City of Santa Fe, New Mexico

memo

2026-012490-HDRB. 507 Paseo de Peralta. Downtown & Eastside Historic District. Marisol Ortiz, agent for Peralta's Walk LLC, owner, proposes to construct a 4,235 sq. ft. multi-family residence to a height of 24'-0" where the maximum allowable height is 25'-0" on a vacant lot.

Figure 3: Proposed Site Plan

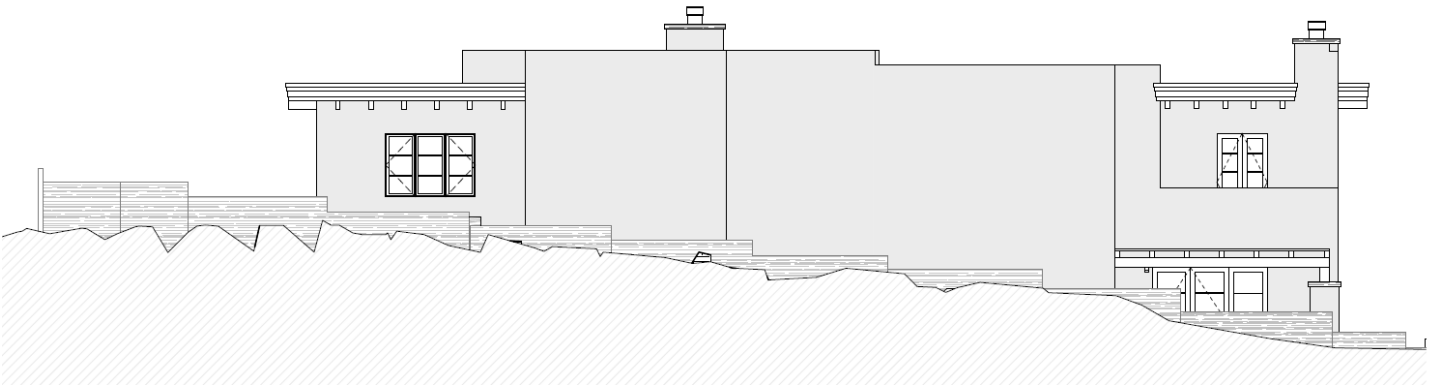
Differences Between Previously Approved and Current:

First Floor:

1. Unit 1, change from a single door and double window to a double door and single window under the portal.
2. Unit 2, change from a single door and double window to a double door and single window under the portal.
3. Unit 3, change from a single door and double window to a double door and single window under the portal.
4. Unit 4, change from a single door and double window to a double door and single window under the portal.

Second Floor:

1. Unit 3, change the single window and single door to double doors with no windows on the deck.
2. In Unit 3, in Bed 1, install two single windows instead of the double window.

Figure 8: Full Project Site Plan

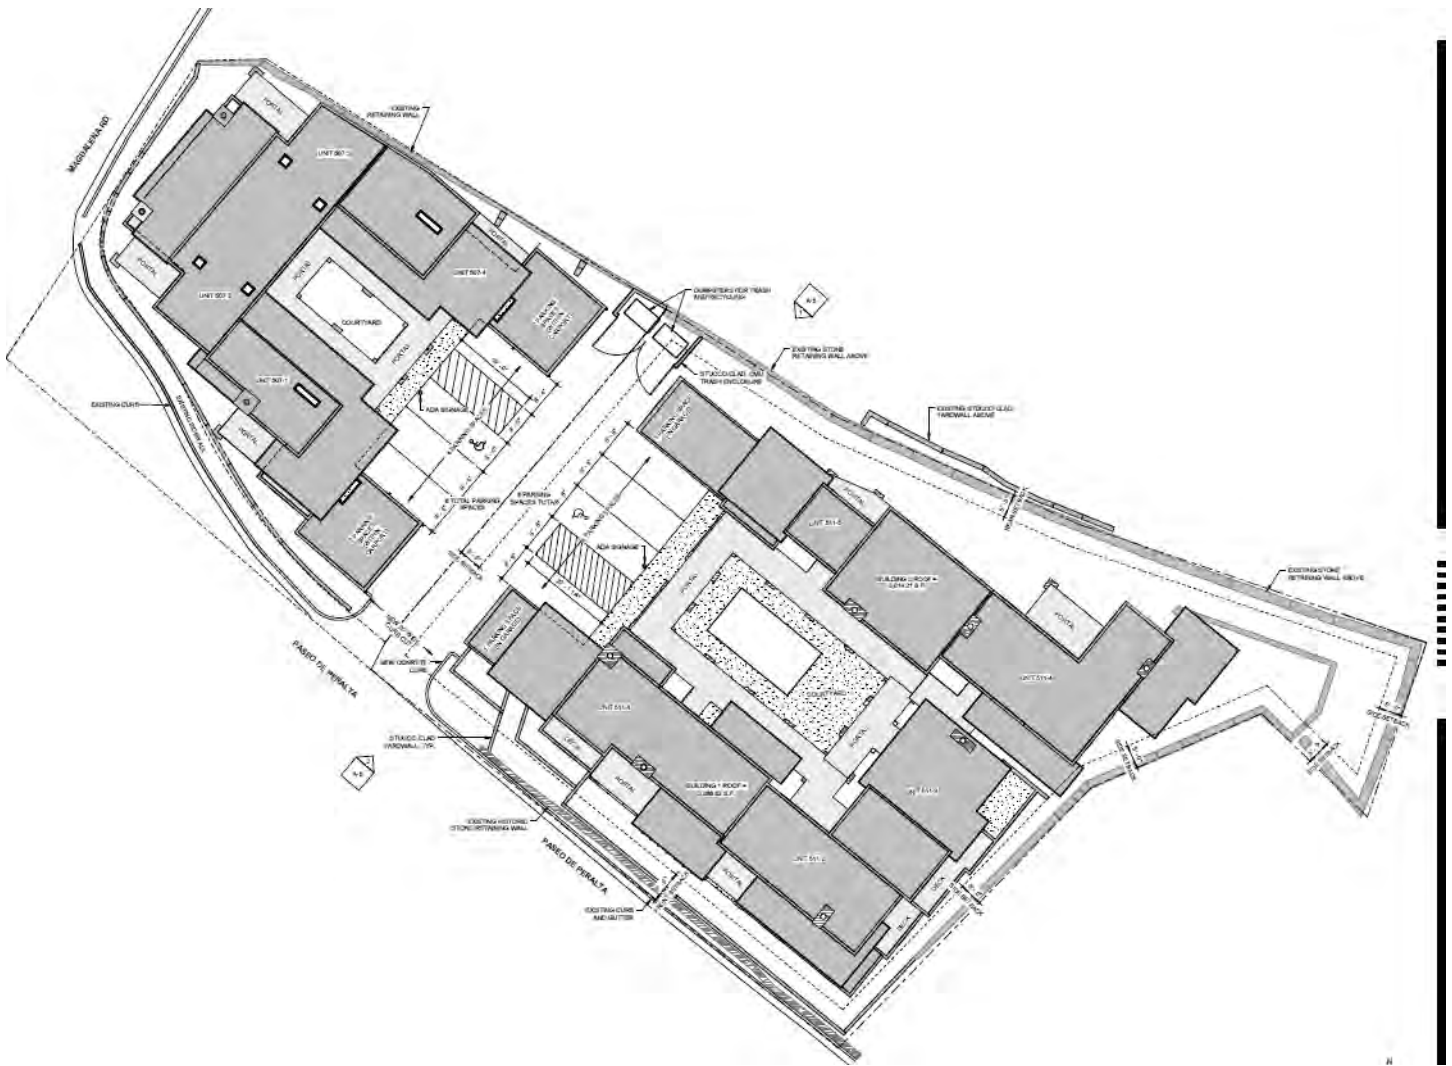
This project works in unison with the project planned at 511 Paseo de Peralta. The overall project with both addresses roofed area will be 10,447 sq. ft. The full project will have a single driveway entrance to the shared parking area.
